**CITY OF ALBUQUERQUE  
PLANNING DEPARTMENT  
September 21, 2005  
DRB Comments**

**Project # 1004413**

**RE: Alvarado Gardens, unit 2/sketch**

DEVELOPMENT REVIEW BOARD--SPEED MEMO

PLAT OF  
 LOTS 43-A, 43-B, 43-C & 43-D  
 ALVARADO GARDENS, UNIT No. 2  
 SECTION 1, T. 10 N., R. 2 E., N.M.P.M.  
 CITY OF ALBUQUERQUE  
 BERNALILLO COUNTY, NEW MEXICO  
 JULY, 2005  
 SHEET 2 OF 2

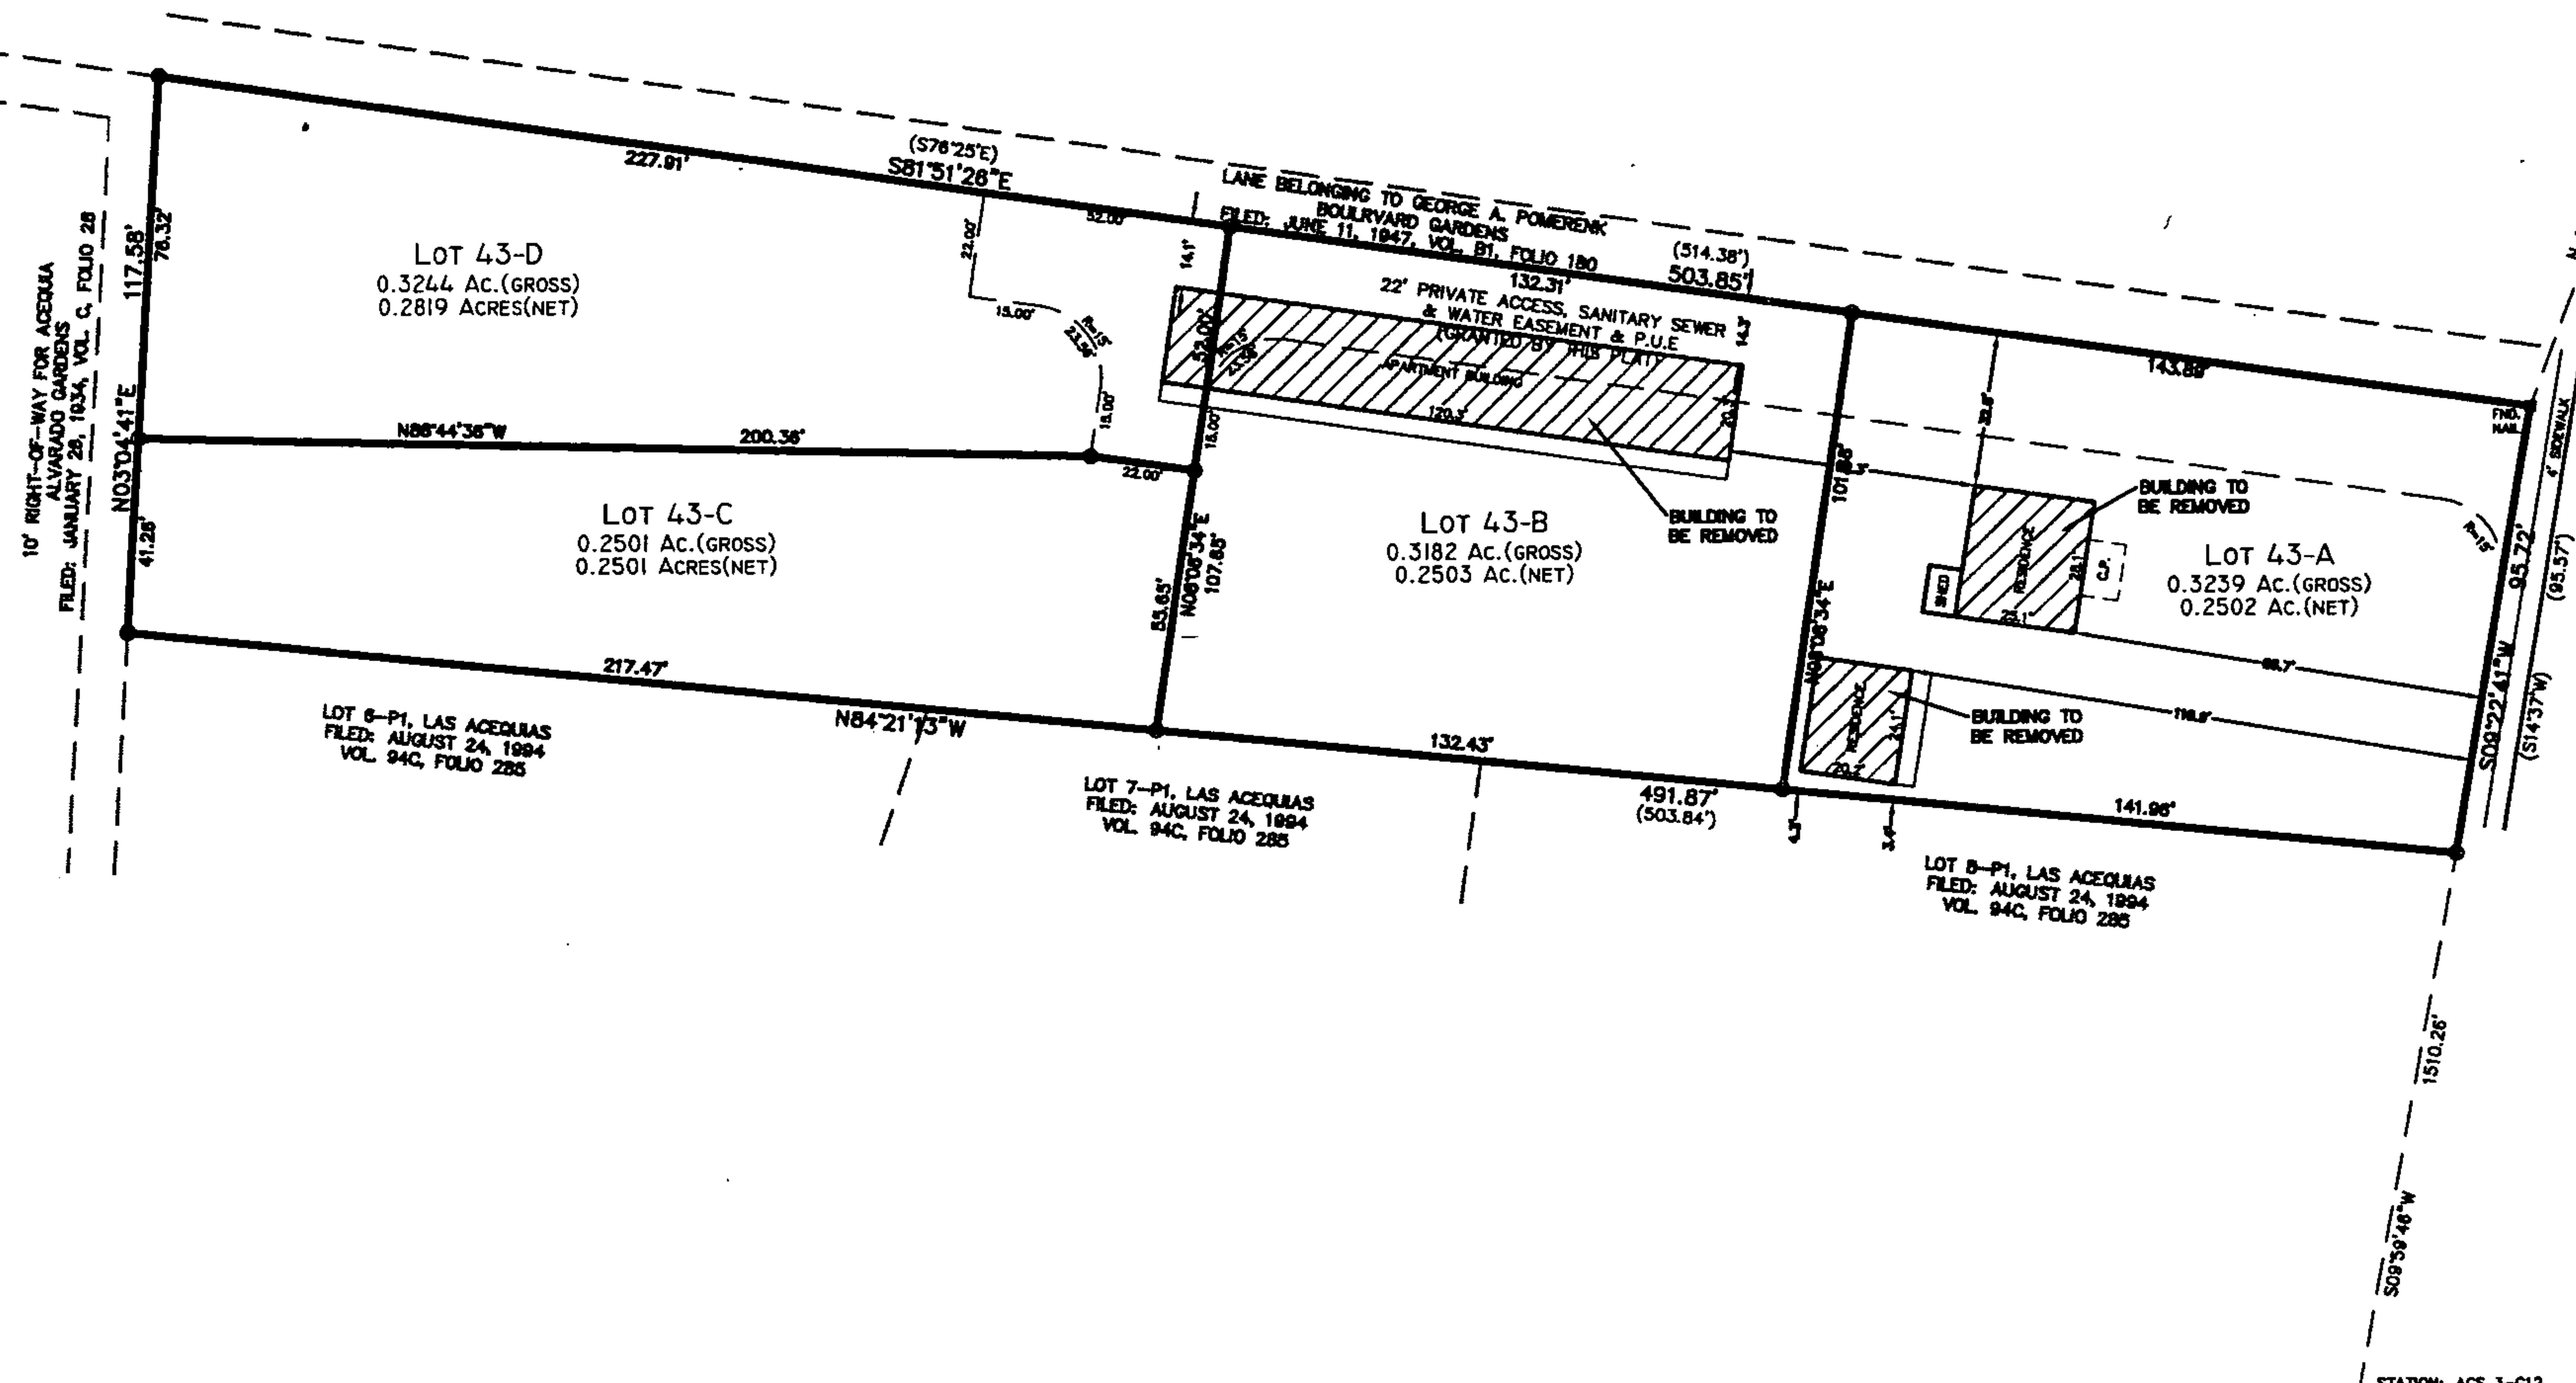
Lot 43-D does not have the required lot width per the RA-2 zone.

Lot 43-C does not have the required lot width per the RA-2 zone.

Need proof of demolition of existing structures prior to Planning signing the plat.

An approved drainage plan is required for Preliminary Plat approval.

1. Must request a Water/Sewer Availability Statement prior to Preliminary Plat approval.
2. For a 4 lot subdivision, public water/sewer line extensions will be required. Minimum public easement width will be 25, with a separate 10' wide PUE for a total easement encumbrance of 35'.
3. A 3 lot subdivision would allow private water/sewer service lines within the private easement as shown.
